PLANNING COMMISSION MEETING

LOCATION: TOWNSHIP ANNEX, 7527 HIGHLAND ROAD, WHITE LAKE, MI 48383
THURSDAY, SEPTEMBER 05, 2024 – 6:30 PM

**WHITE LAKE TOWNSHIP
PLANNING COMMISSION
AUGUST 15, 2024**

Table with columns for TOWNSHIP COMMENTS, MDOT COMMENTS, and REVISION PER. Includes fields for DESIGNED BY (ST), DRAWN BY (DH), CHECKED BY (BL), SCALE (NO SCALE), JOB NO (22-029-1), DATE (05/30/24), SHEET NO (2), and BOSS Engineering logo.

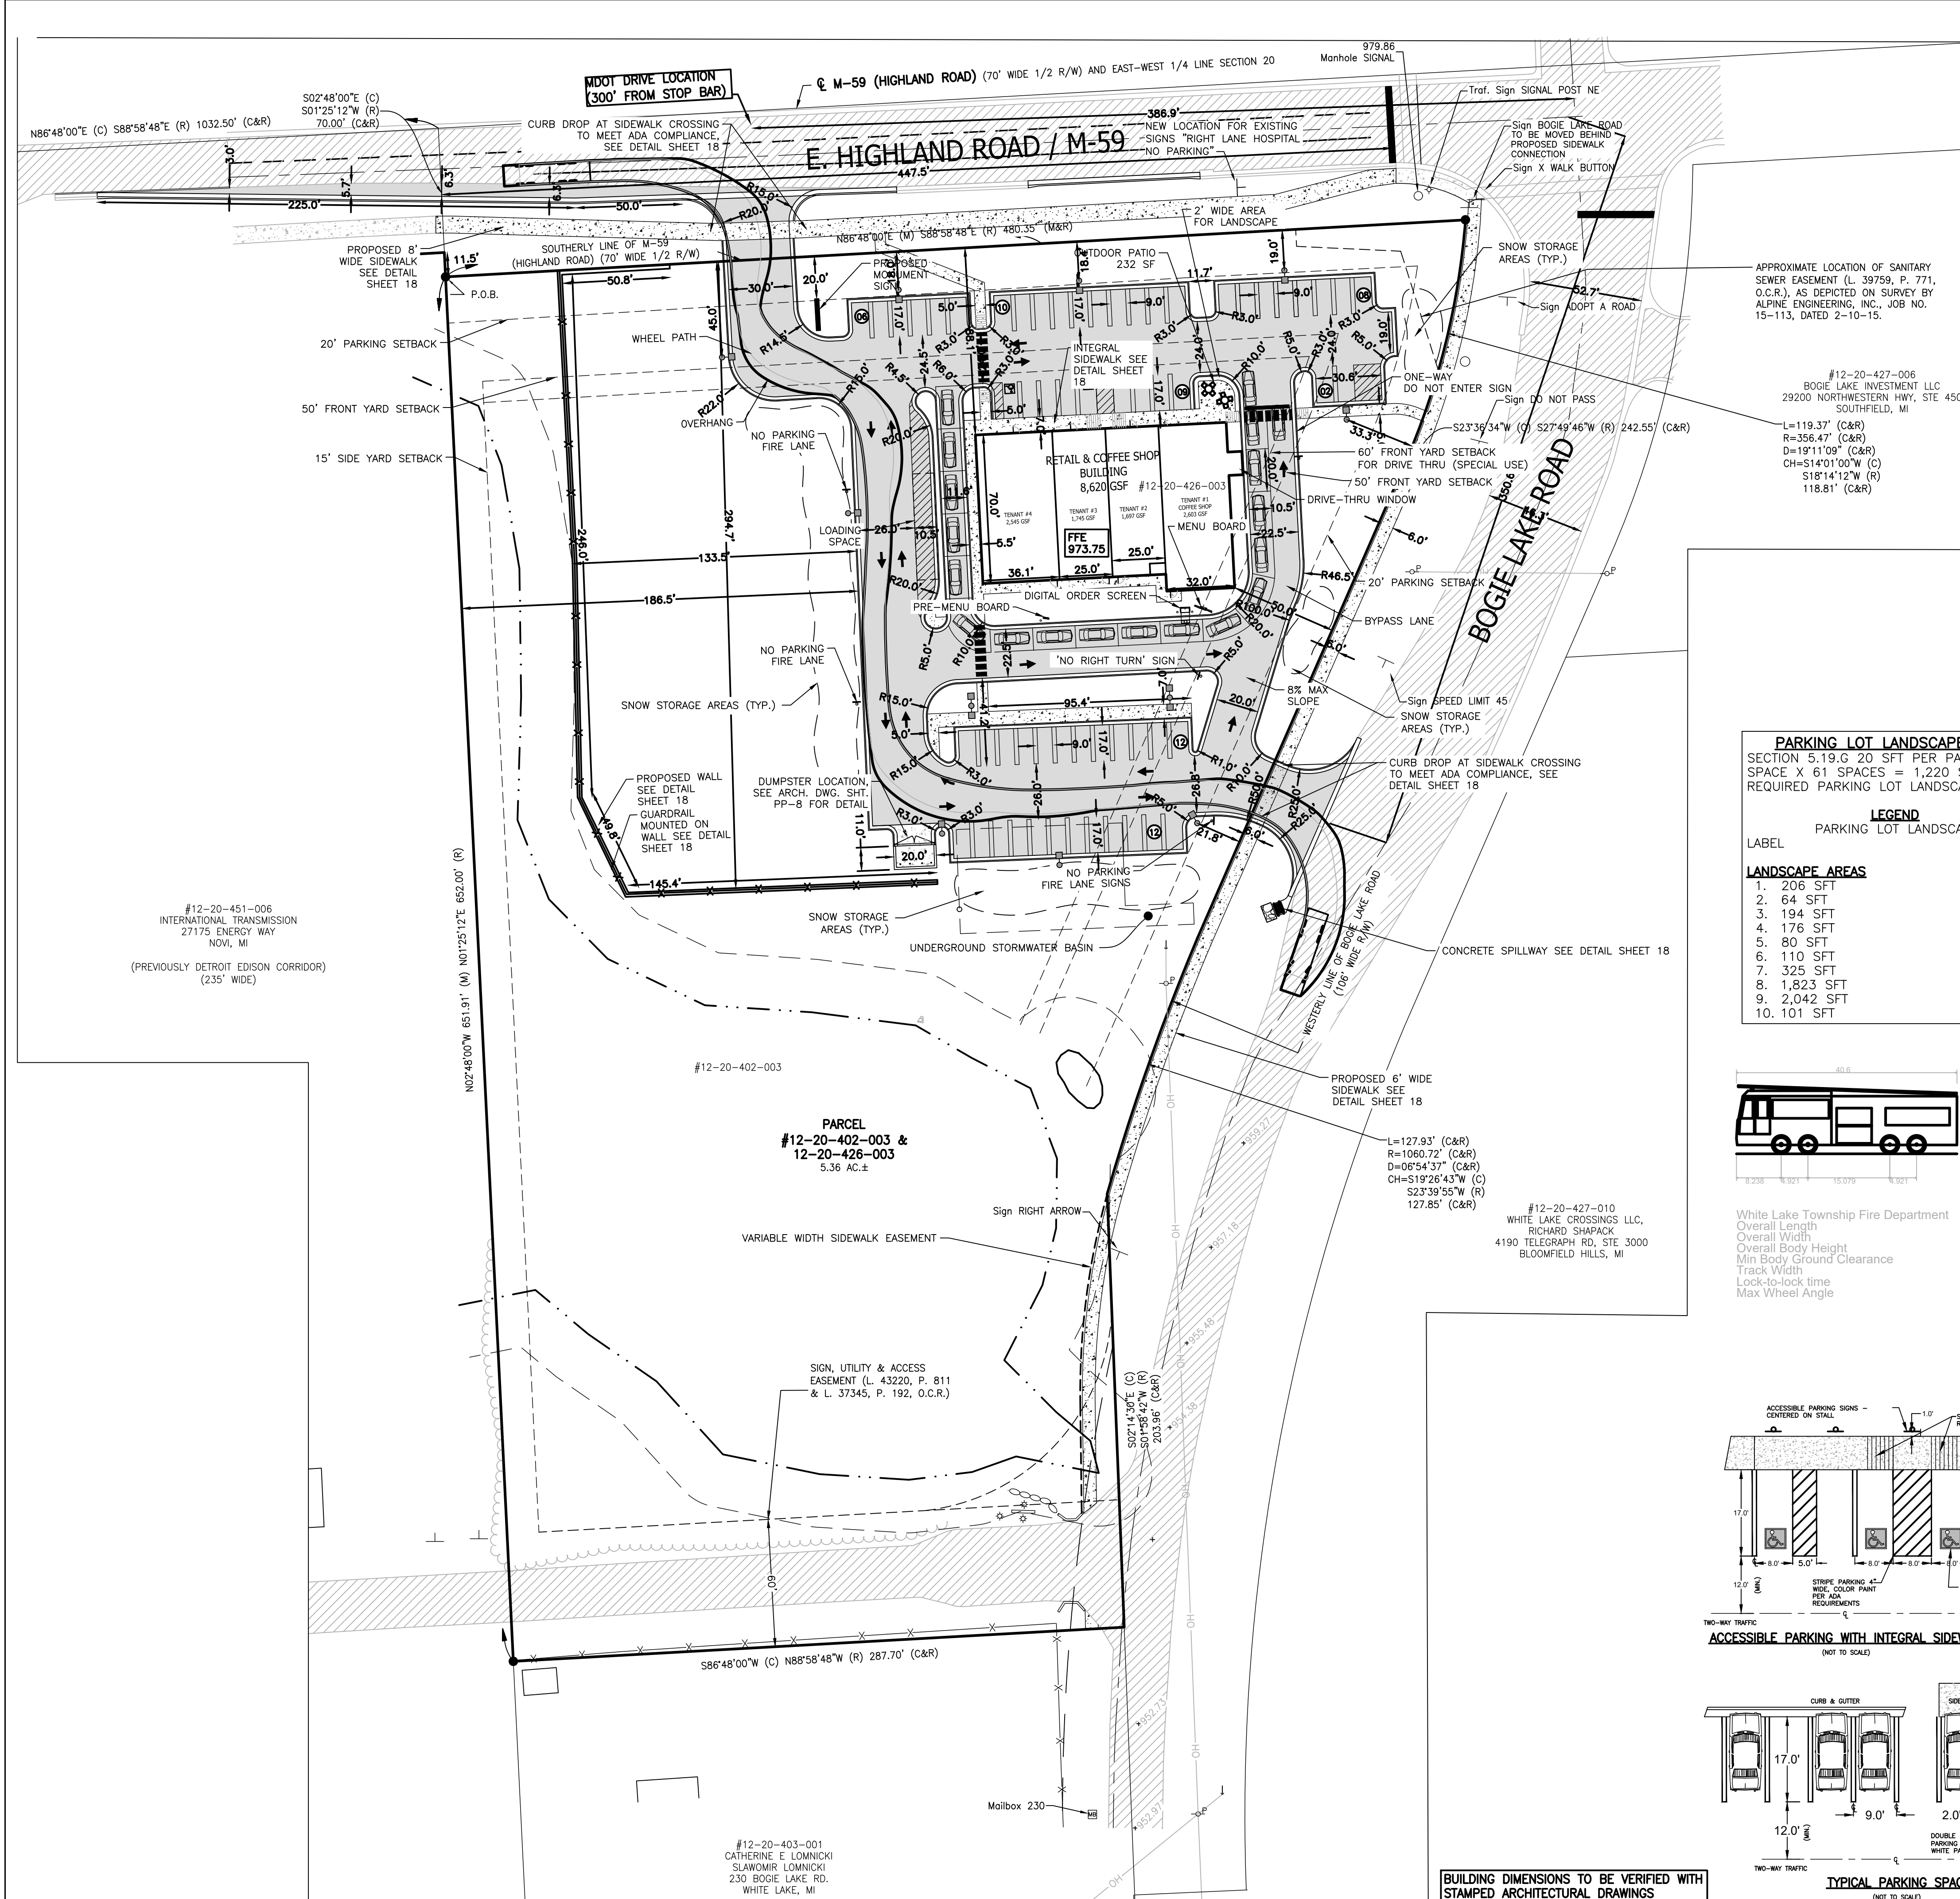
4. *Sheet 2- General Storm Notes – Remove Notes 2 (including 2.1-2.4) and 9.* **Comment addressed. Notes have been removed.**
5. *Sheet 2- General Storm Notes- Revise Note 6- “All flared end sections 18” and larger...”* **Comment addressed. Note has been revised.**

6. *Sheet 2- General Sanitary Notes- Remove Note 9.* **Comment addressed. Note has been removed.**
7. *Sheet 2- General Sanitary Notes-Note 12- Change footage from “100’ “to “75’ and.”* **Comment addressed. Footage has been revised.**

8. *Sheet 2- General Sanitary Notes- Note 13- Replace “XX” with “20.”* **Comment addressed. Note has been revised.**
9. *Sheet 2- General Watermain Notes- Remove Note 1.* **Comment addressed. Note has been removed.**

10. *Sheet 2- General Watermain Notes- Note 7- Change watermain minimum cover from 5.5’ to 6.0’.* **Comment addressed. Note has been updated.**
11. *Sheet 2- General Watermain Notes- Note 11- Replace “XX” with “20.”* **Comment addressed. Note has been revised.**

PROJECT	PREPARED FOR	TITLE
GATEWAY CROSSING	GATEWAY CROSSING, LLC	UTILITY PLAN
DESIGNED BY:	DRAWN BY:	CHECKED BY:
ST	DH	
SCALE: 1" = 40'	JOB NO: 22-029-1	DATE: 05/30/24
TOWNSHIP COMMENTS: 8/6/24	MDOT COMMENTS: 7/9/24	REVISION PER: NO BY:
2 MJD	1 MJD	
SHEET NO. 5

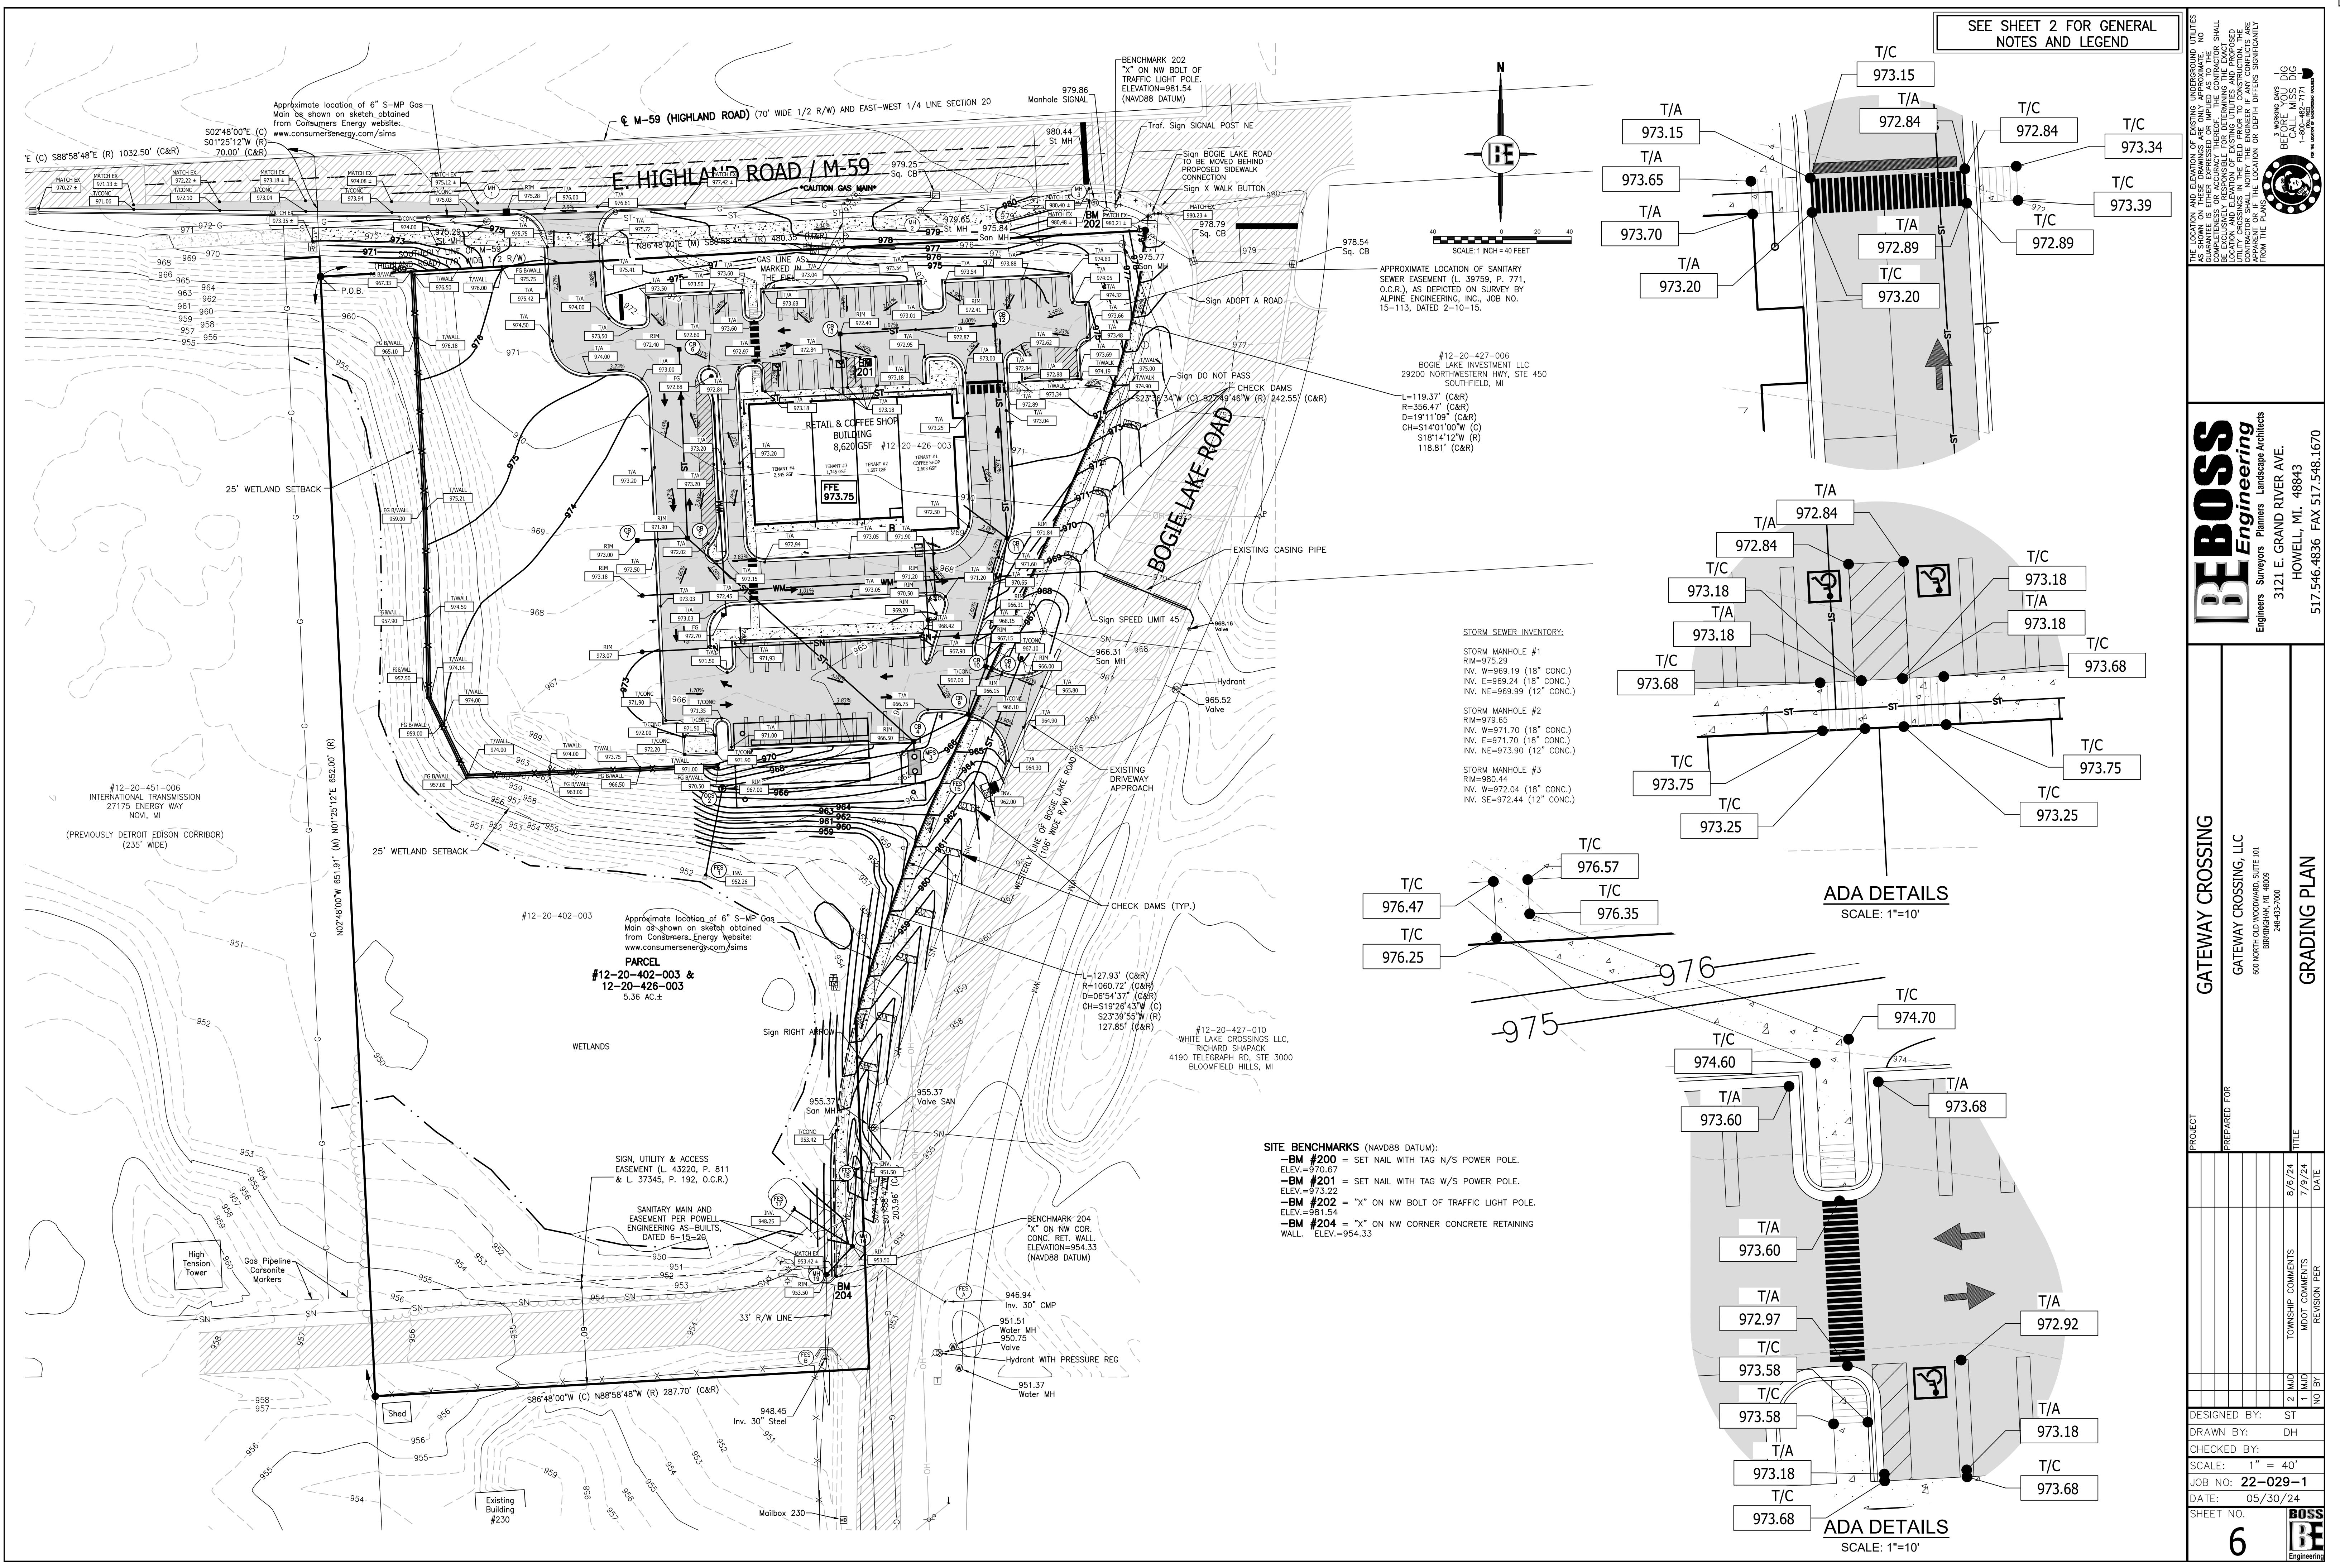
1. *Sheet 5- The utility plan shall provide sanitary sewer lengths between structures, pipe slopes, type, and diameter.* **Comment addressed. Information has now been shown on utility plan.**
2. *Sheet 5- Sanitary sewer pipe material is proposed as PVC SCH 40; SDR 26 is required for sewer mains, and SDR 23.5 is required for service leads.* **Comment addressed. Materials have been revised.**
3. *Sheet 5- In reference to the 48 LF sanitary sewer lead. Based on the inverts provided in the lead elevations table on Sheet 11, the actual pipe slope calculates to 0.90%. A minimum of 1.00% slope is required for building leads.* **Comment partially addressed. Inverts have been updated on Sheet 11;**

4. *Sheet 5- A minimum of 6" diameter is required for sanitary sewer building leads; currently 4" diameter is proposed. Comment addressed. All leads have been updated to 6" diameter.*

5. *Sheet 5- Provide diameter of monitoring manhole. A minimum 4' diameter is required. Comment addressed. Diameter (4') has been noted on plan.*
6. *Sheet 11- Provide sanitary sewer basis of design including REUs for future development on the western portion of this parcel. Comment partially addressed. Sanitary sewer basis of design has been provided; however, it appear that the future REUs of 7.50 were not factored/included in the total number of REUs (should be approximately 17). Please provide both currently proposed and future REU calculations. Please also use 270 gallons per day per REU per OCWRC requirements for this sewage district.*

3. *Sheet 5- Provide label for GV01 on plan.* **Comment addressed. Label has been provided.**
4. *Sheet 5- Water valve and temporary blowoff assembly- Correct sheet reference from Sheet 14 to Sheet 19.* **Comment addressed. Correct sheet reference has been provided.**

2. *Sheet 5- Remove storm sewer pipe sizing calculations as these are duplicated within the plan set on Sheet 13. Please leave calculations on Sheet 13.* **Comment addressed. Duplicate calculations have been removed from Sheet 5.**

3. *Sheet 5- The utility plan shall provide storm sewer lengths between structures, pipe slopes, type, and diameter.* **Comment addressed. Information has been added to the utility plan.**
